designed for	R.De Salvo	
draw. by	G.Gennaro-PROMECC	
date	16-10-06	scale 1/1
title	HAM OPTICAL BENCH	
detail from	193	A 2

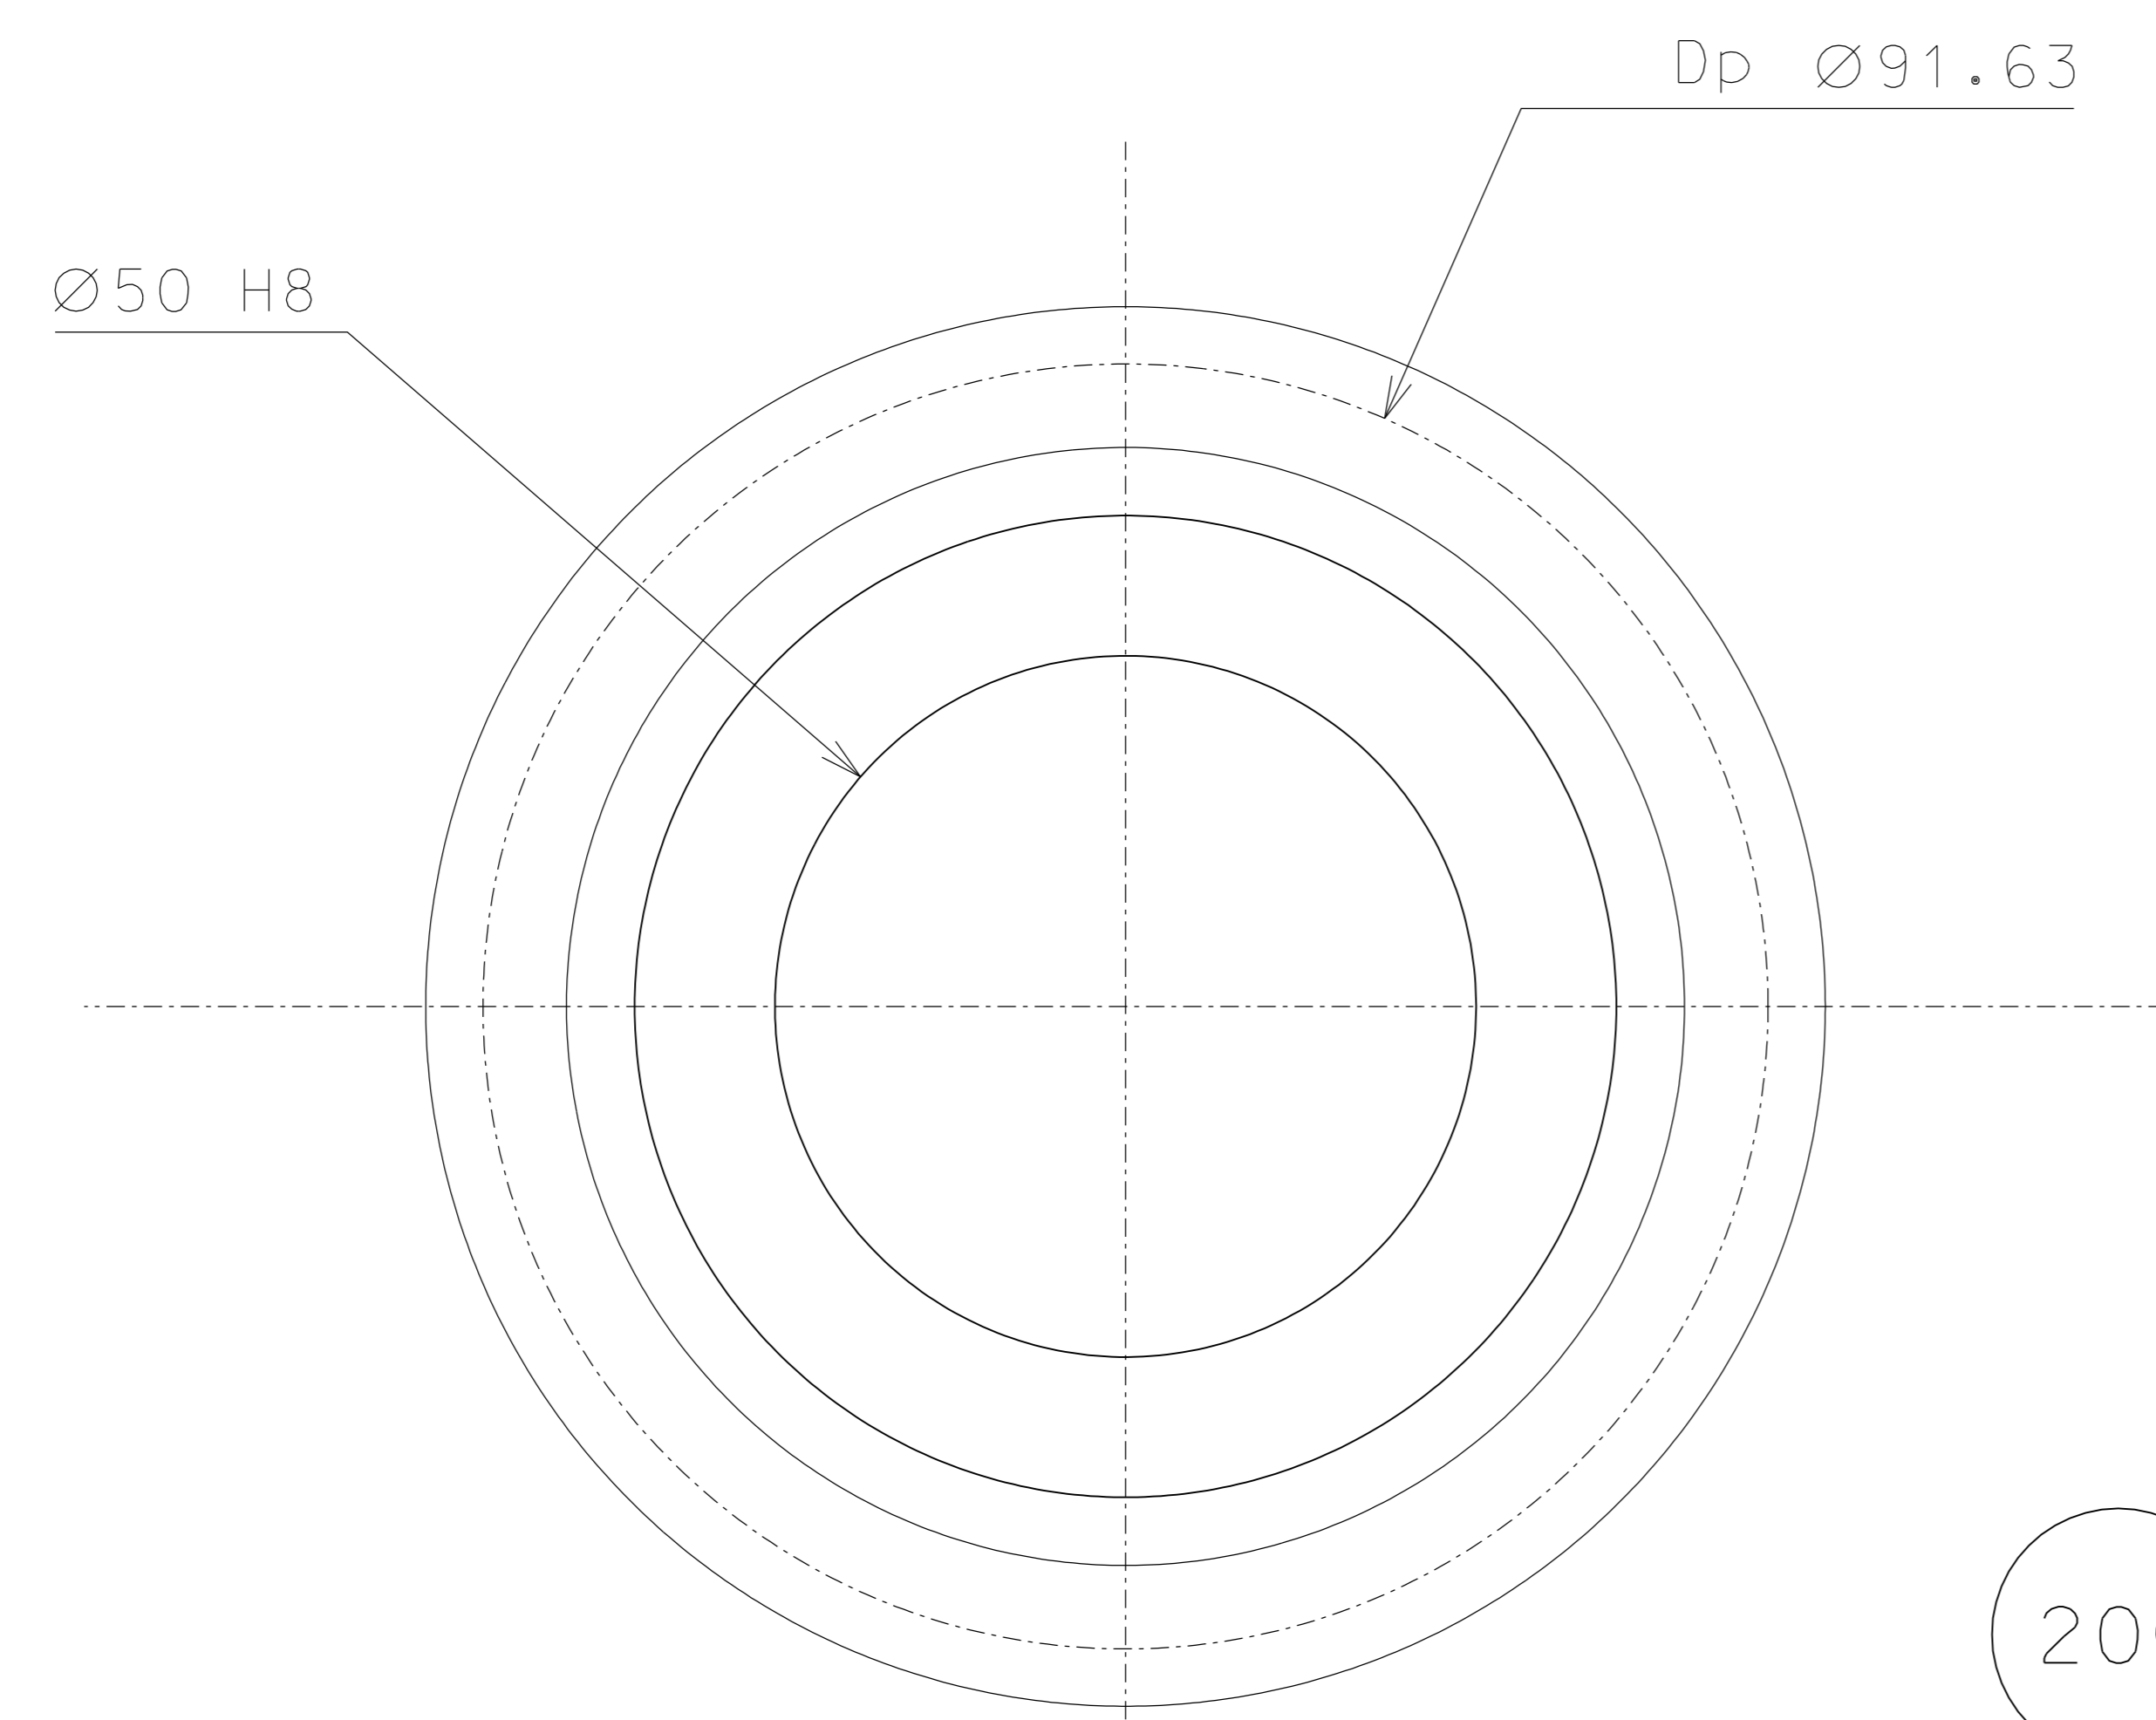
modify gear Z=15, Dp=91.63 for chain 12 A-1
see 22 in the drawing 51193

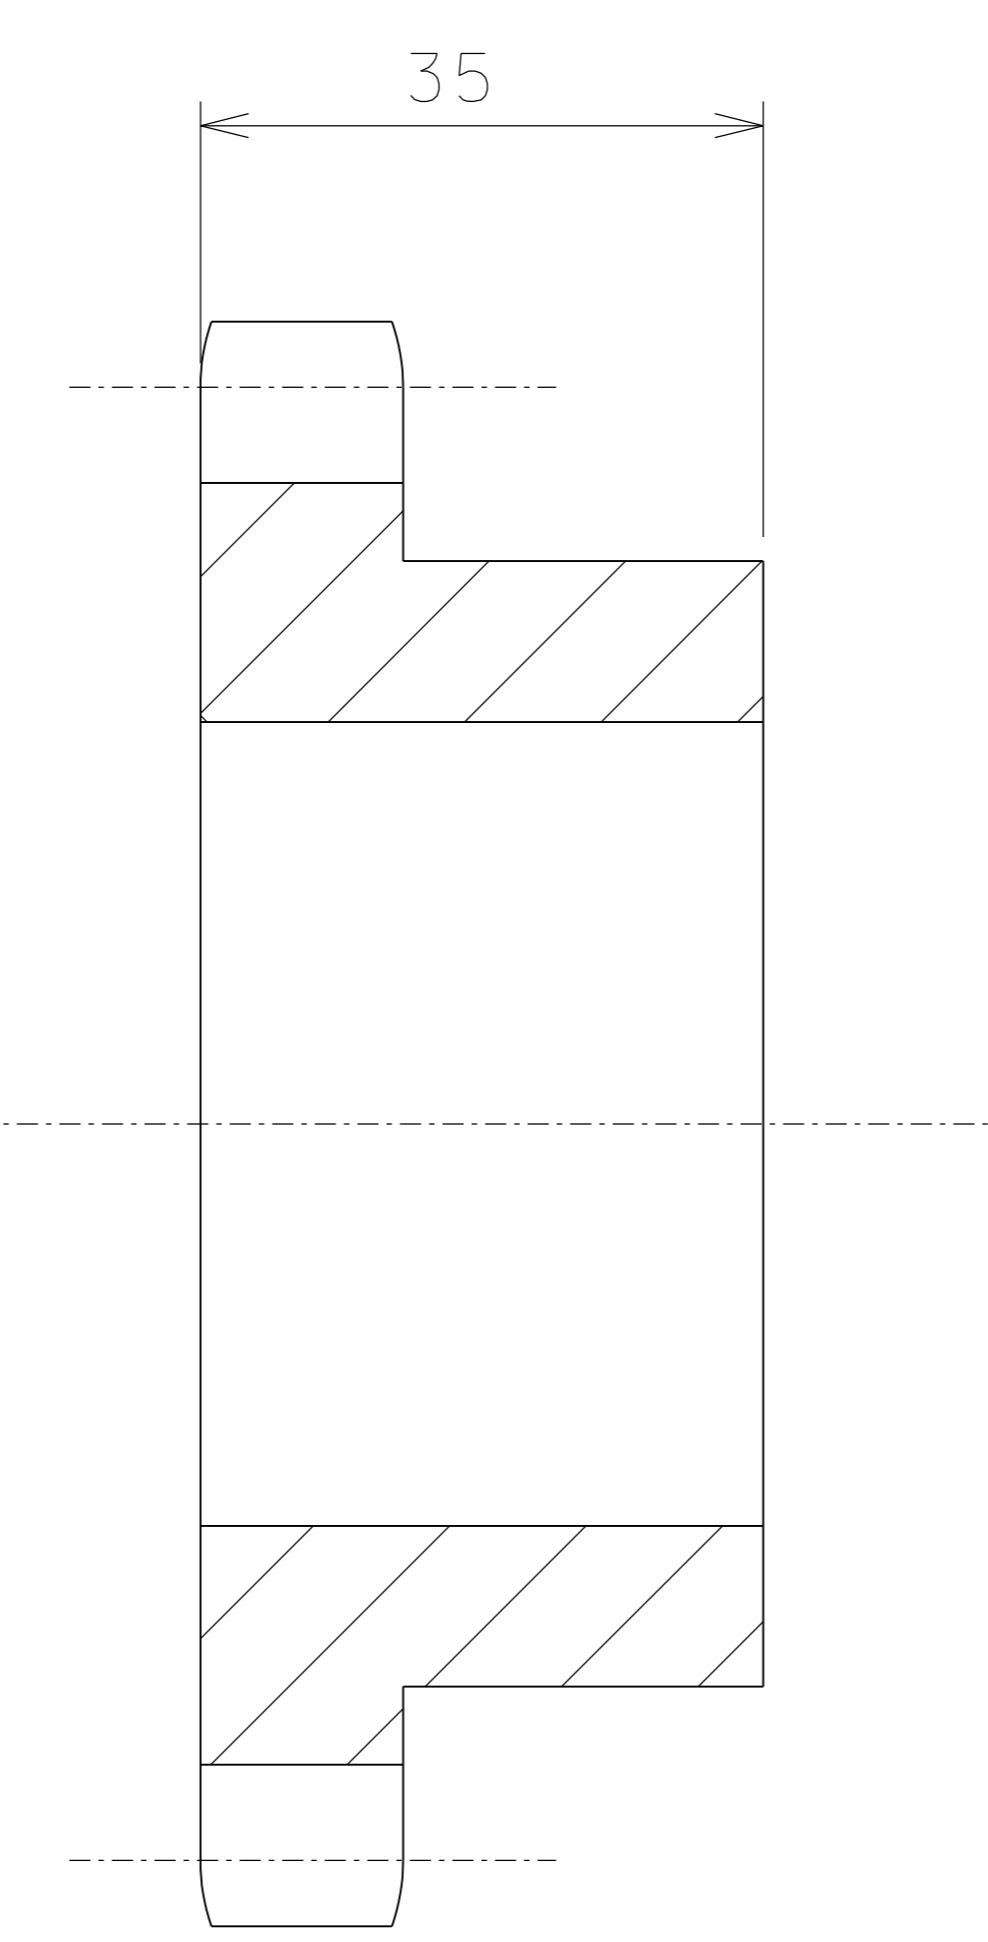
modify gear Z=15, Dp=91.63 for chain 12 A-1
see 22 in the drawing 51193
